ESC Comment Responses shown in this style.

MEADOW POINT CONDOMINIUMS SITE PLAN AMENDMENT

COVER SHEET
THE PEAK AT MEADOW POINT SITE PLAN
4470 SOUTH PITKIN STREET
LOT 1, BLOCK 1, THE PEAK AT MEADOW POINT SUBDIVISION
FILING NO. 1
CITY OF AURORA, COUNTY OF ARAPAHOE, STATE OF COLORADO

1 LIGHTING PHOTOMETRIC PLAN
SCALE: 1" = 30'-0"

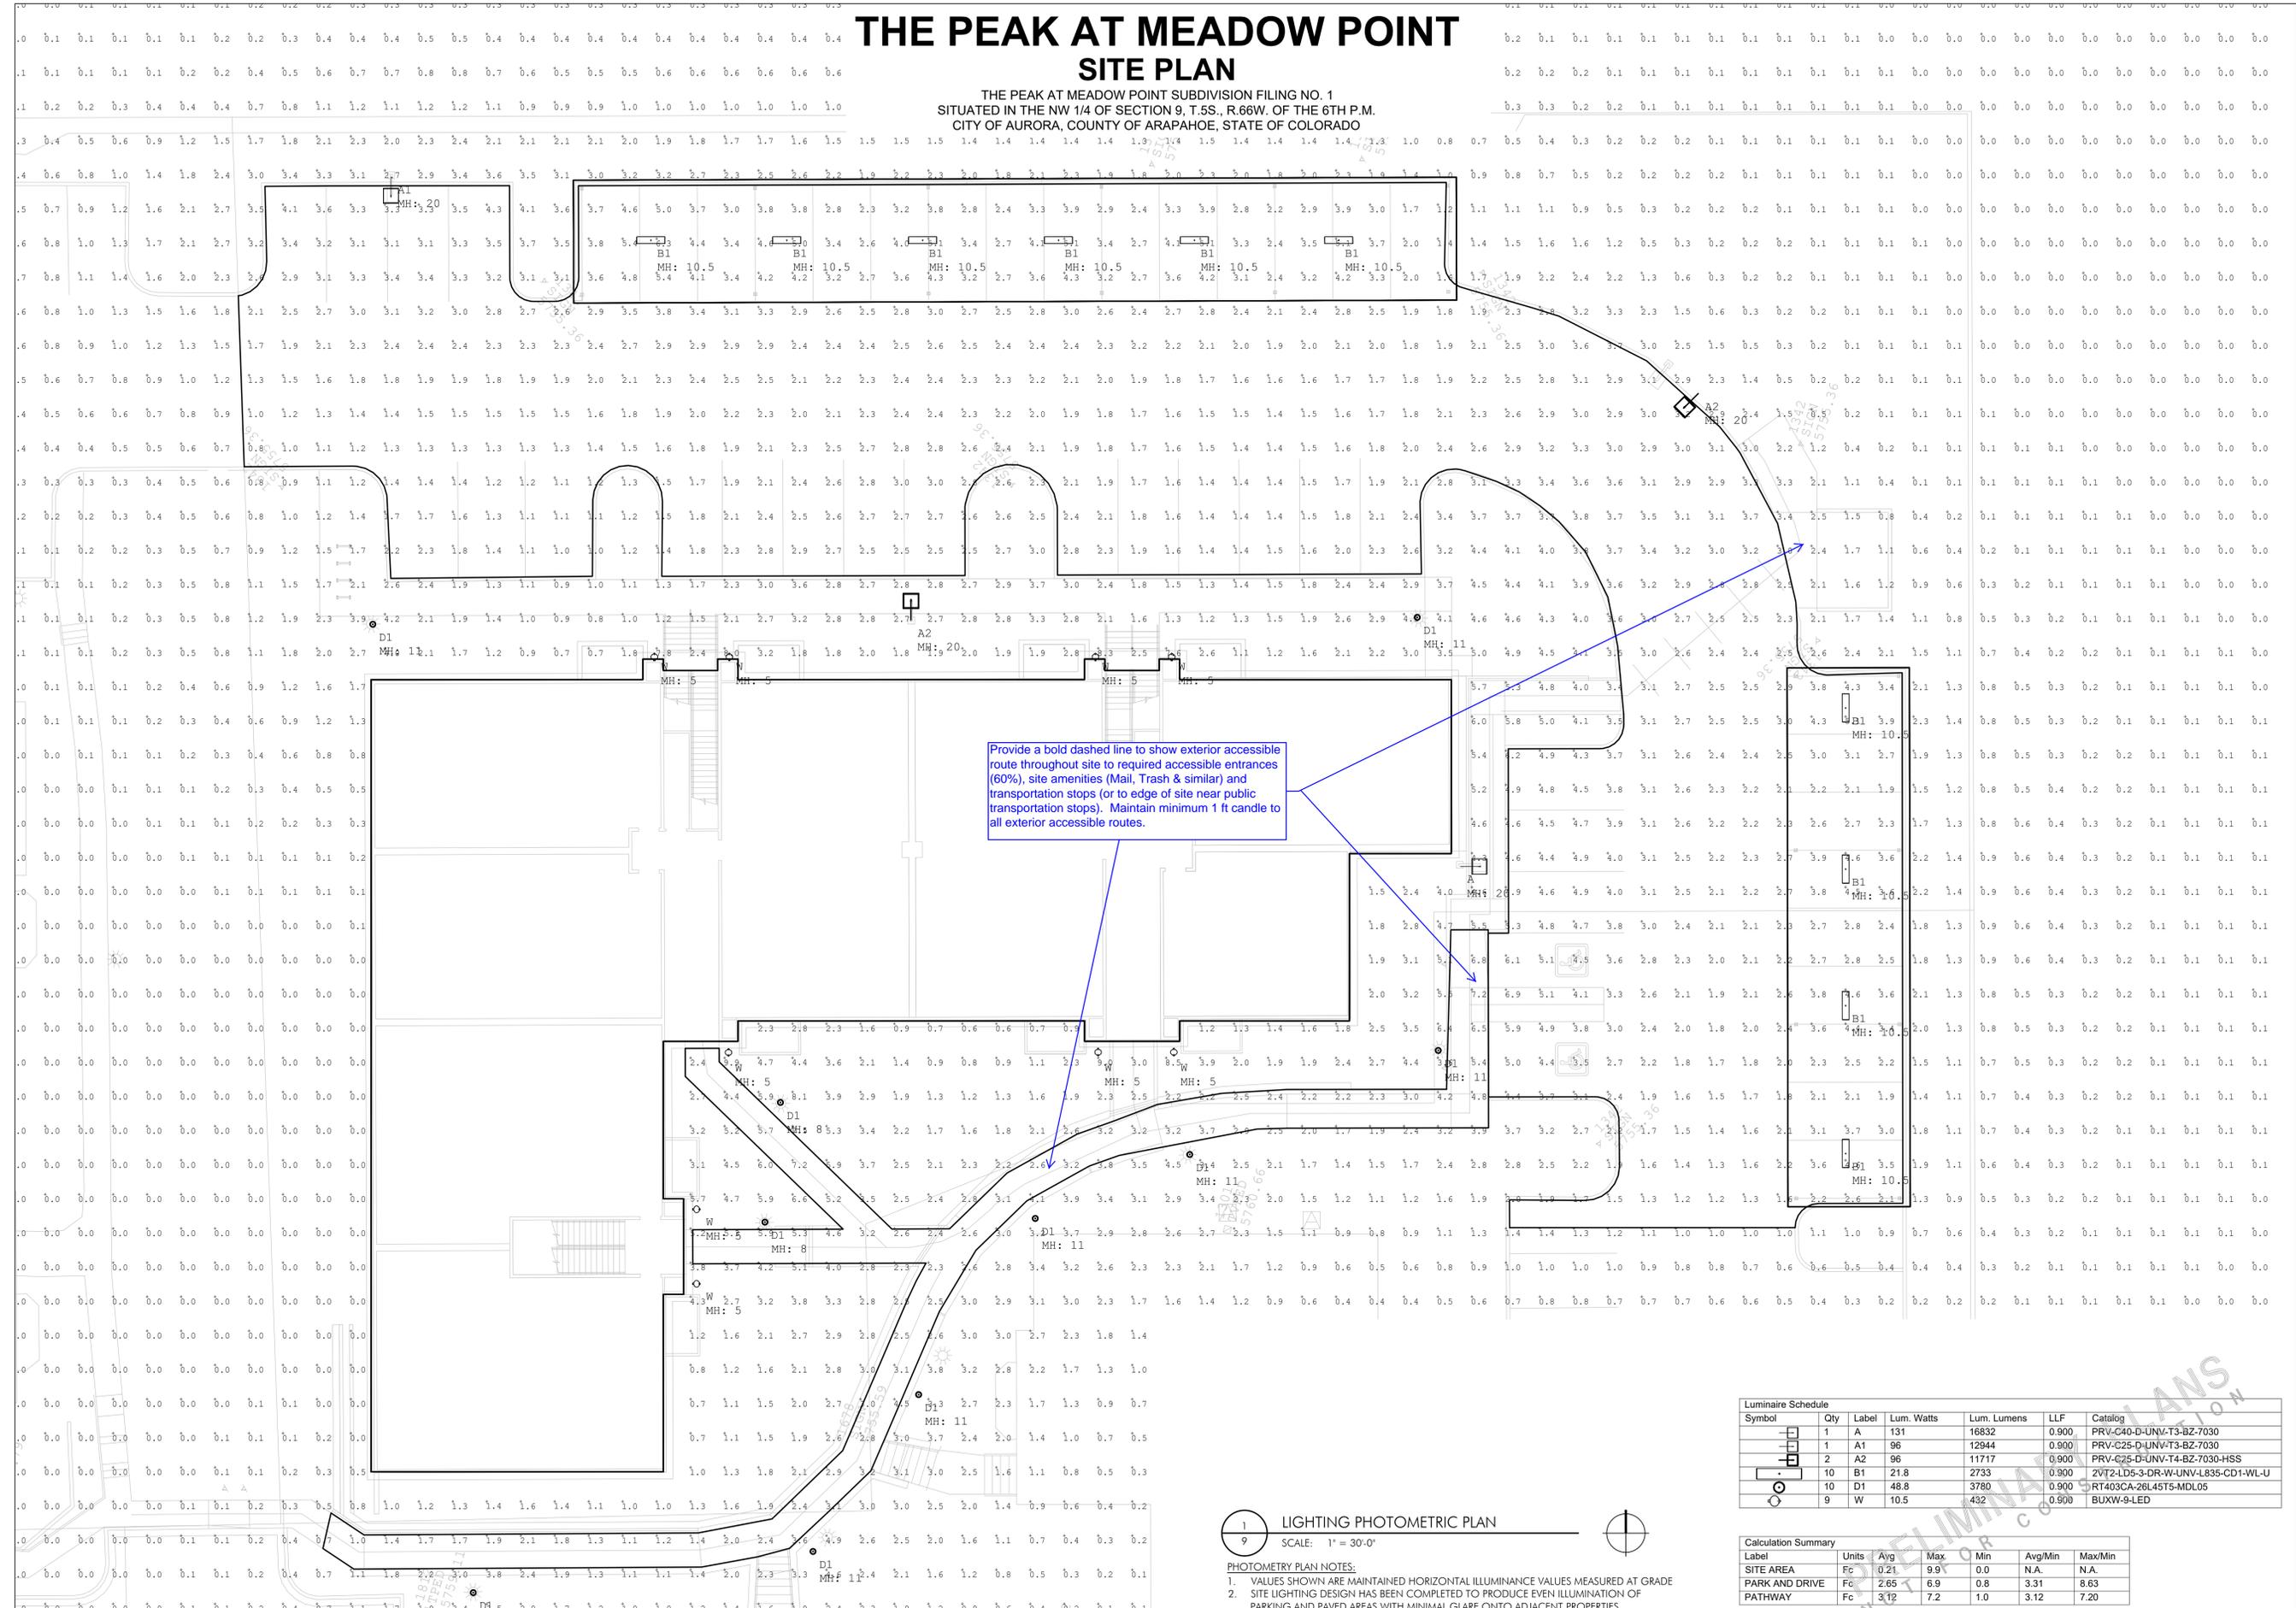
Provide a bold dashed line to show exterior accessible route throughout site to required accessible entrances (60%), site amenities (Mail, Trash & similar) and transportation stops (or to edge of site near public transportation stops). Maintain minimum 1 ft candle to all exterior accessible routes.
